REGULAR MEETING – PLANNING AND ZONING COMMISSION AGENDA

**JULY 2, 2025, 6:00 PM
BY ZOOM VIRTUAL MEETING**

- A. #2025-47 SP - 186 Westport Ave LLC - 186 Westport Avenue (District 5, Block 4, Lot 151) - Special permit for existing car wash to add motor vehicle repair use - Public hearing, report & recommended action**
- B. #2025-40 SP - Mayra Garcia - 43 Bettswood Road (District 5, Block 5, Lot 70) - Special permit application for a Child Day-Care Center use - Public hearing, report & recommended action**

- A. #2025-52 SP Modification - St. George Greek Orthodox Church - 238 West Rocks**

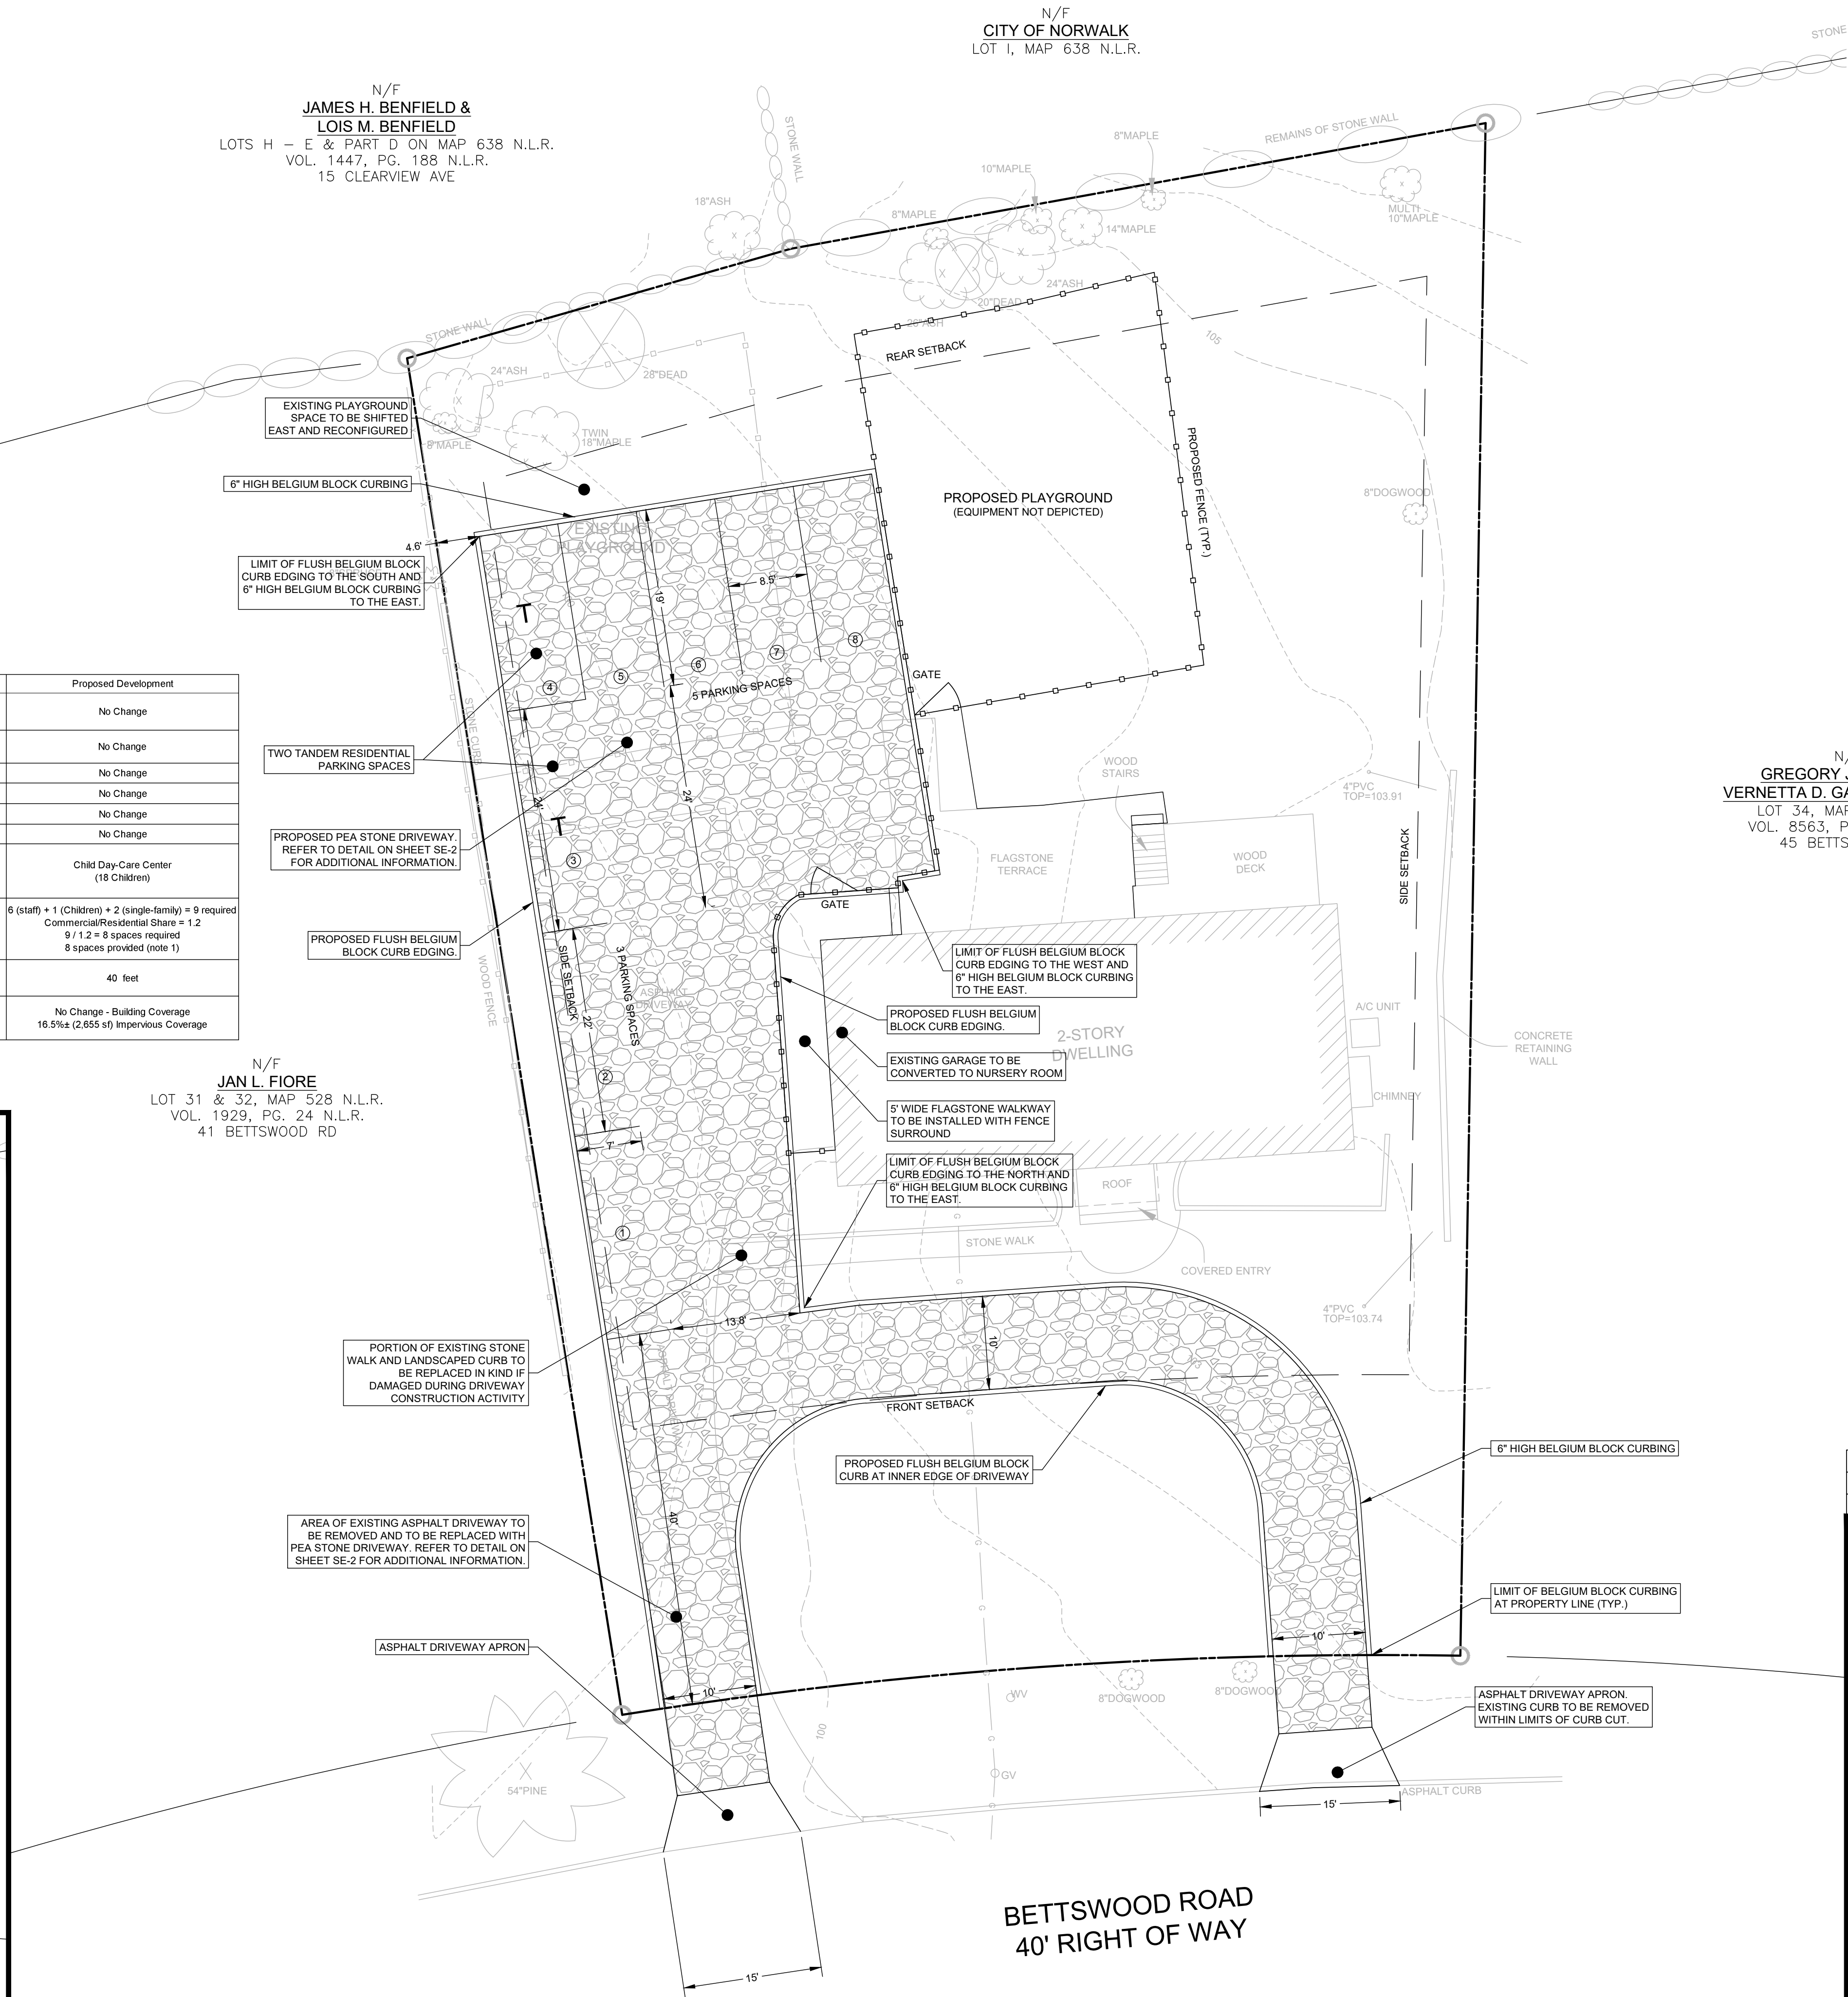
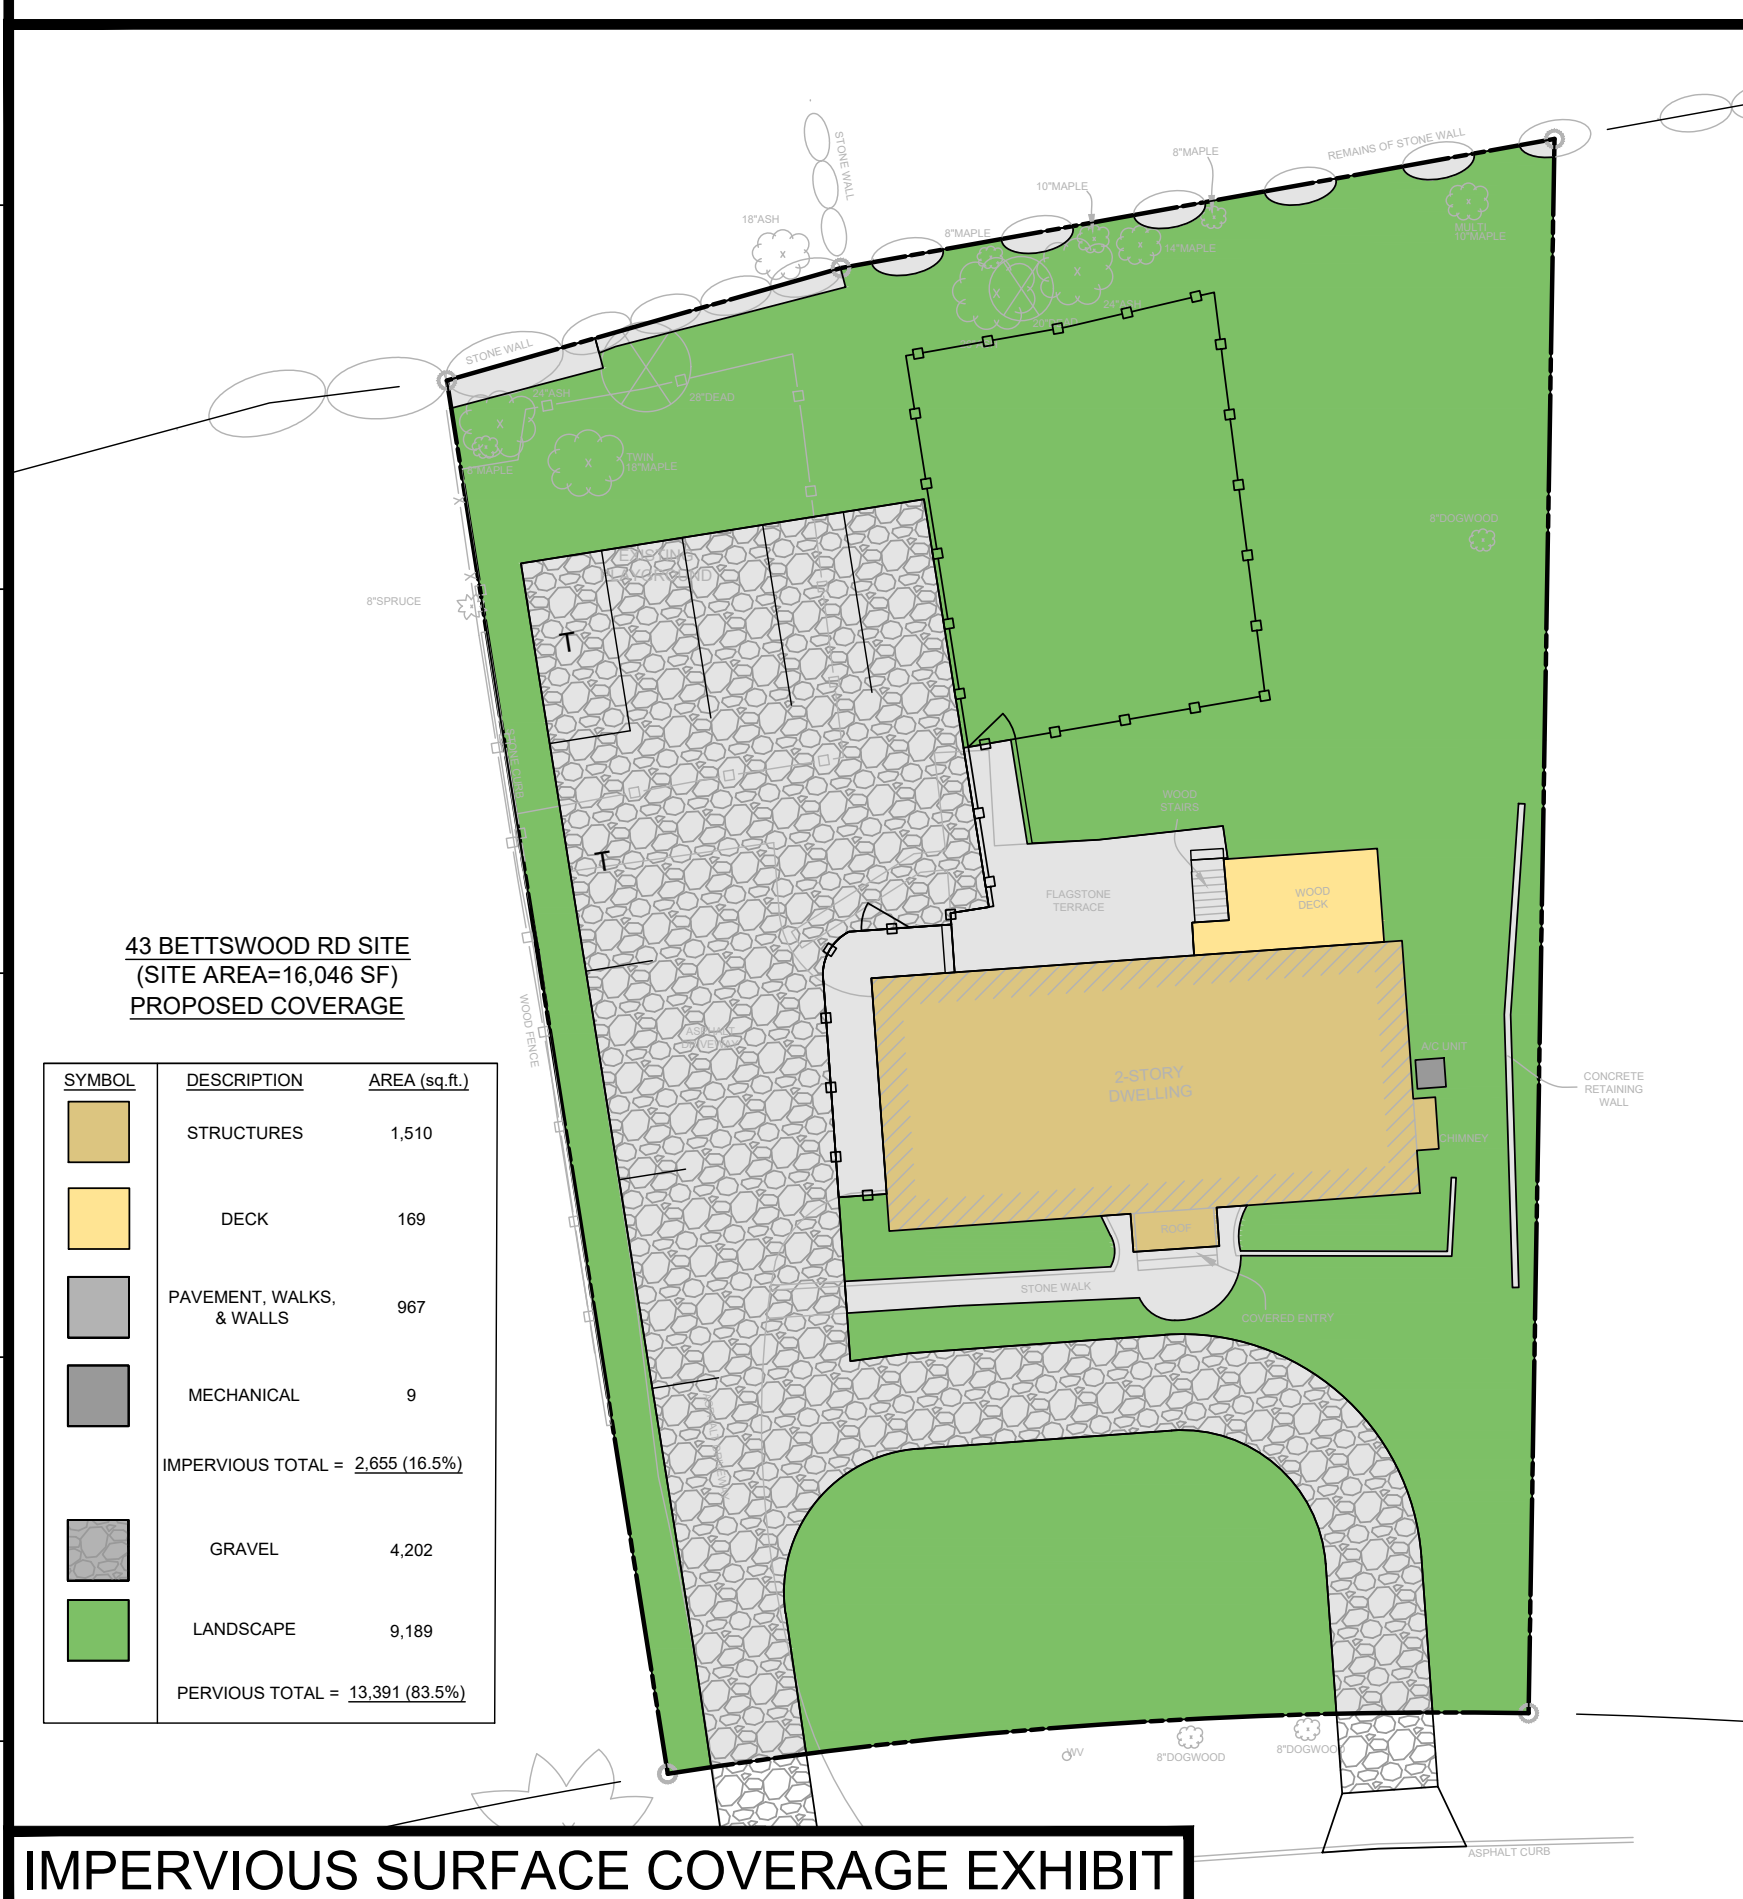
- 6) Comment (6/5/25): *The proposed driveway plan does not comply. However, I have attached a marked up option attached in this email.*

Comment (6/9/25): *Required on-site parking including the single family use would require 9 total on site spaces. 7 for daycare and 2 for single family use.*

Response: Refer to the revised site plan package which depicts the designated parking spaces and drive aisles behind the front yard setback. We have depicted 8 spaces based upon the shared parking nature of the single-family residence and the commercial use. As tandem spaces are allowed for residential use (standard 4.3.12.B.19.c), two of the spaces are tandem and will be noted as residential parking only.

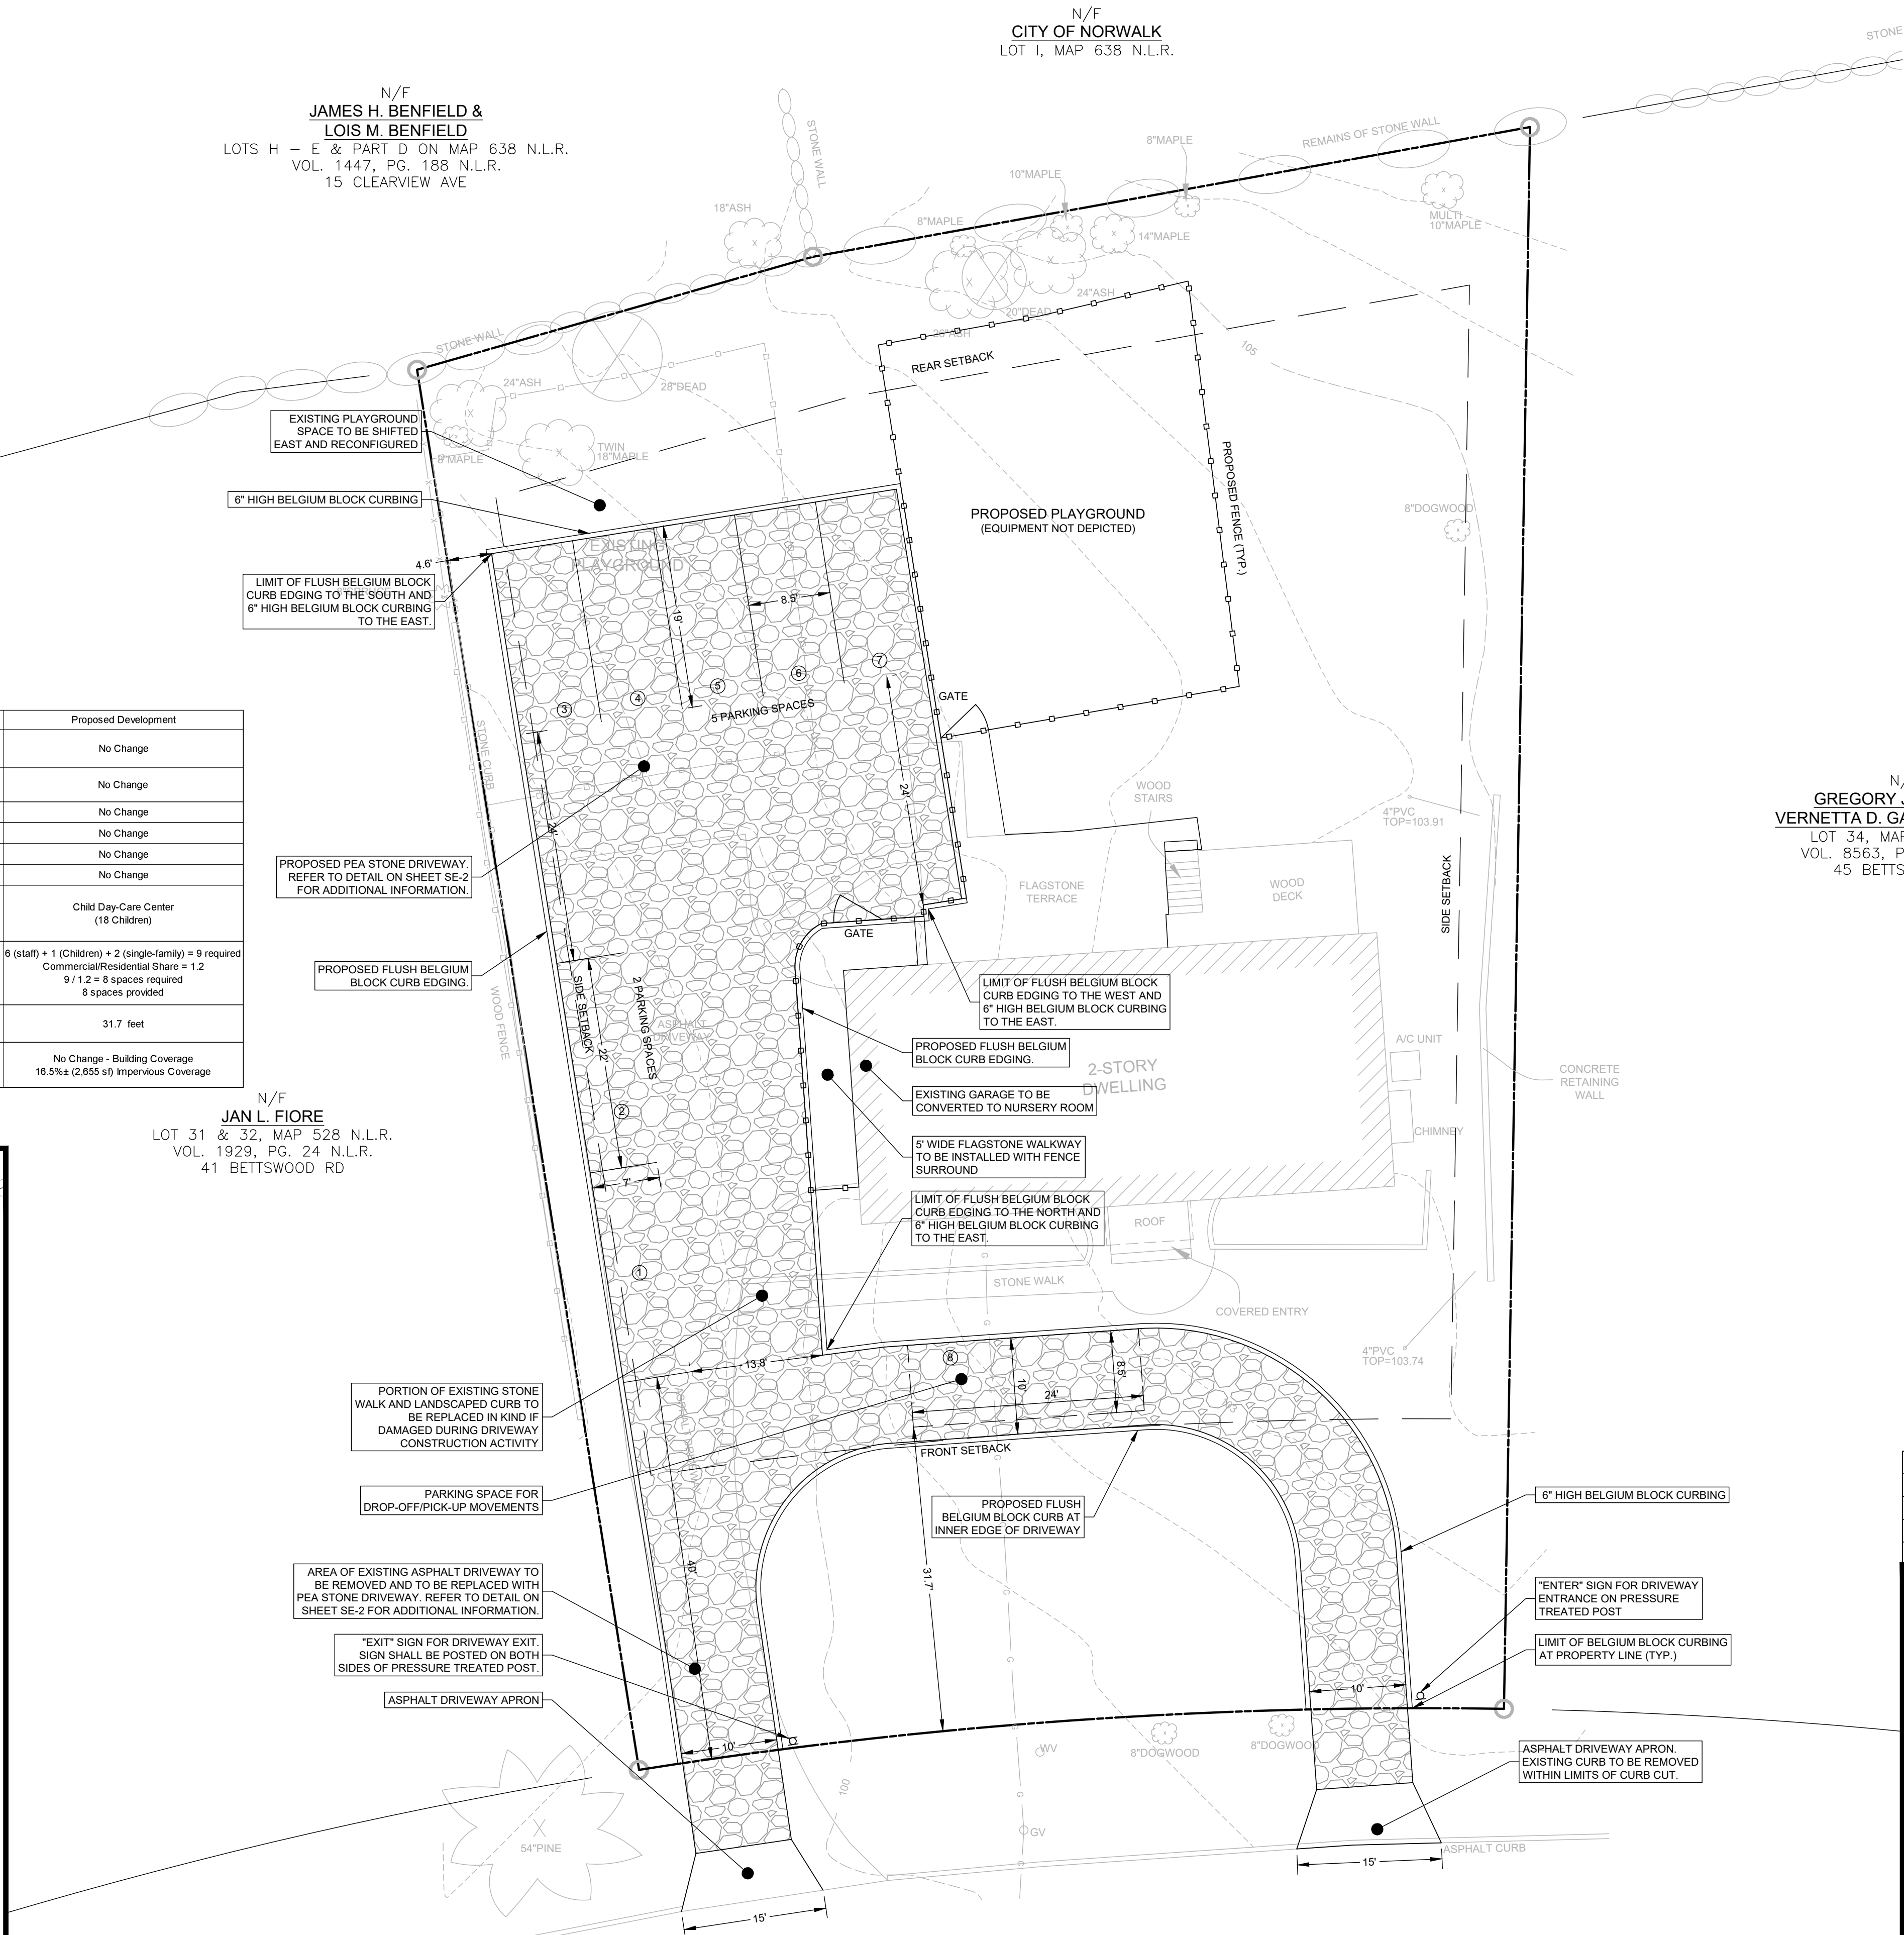
1. Please confirm whether the driveways are both one-way (i.e. the east driveway curb cut is enter only and the west driveway curb cut is exit only) due to the narrow width of the loop driveway. If so, will there be signage installed to clarify the entry and exit?
2. Please rectify the discrepancy between the parallel parking space detail on Sheet SE-2 and the dimensions on the plan (Sheet ZSP-1).

2	06/25/2025	REVISED PER TMP COMMENTS
1	05/21/2025	ORIGINAL ISSUE DATE
No.	Date	Revision
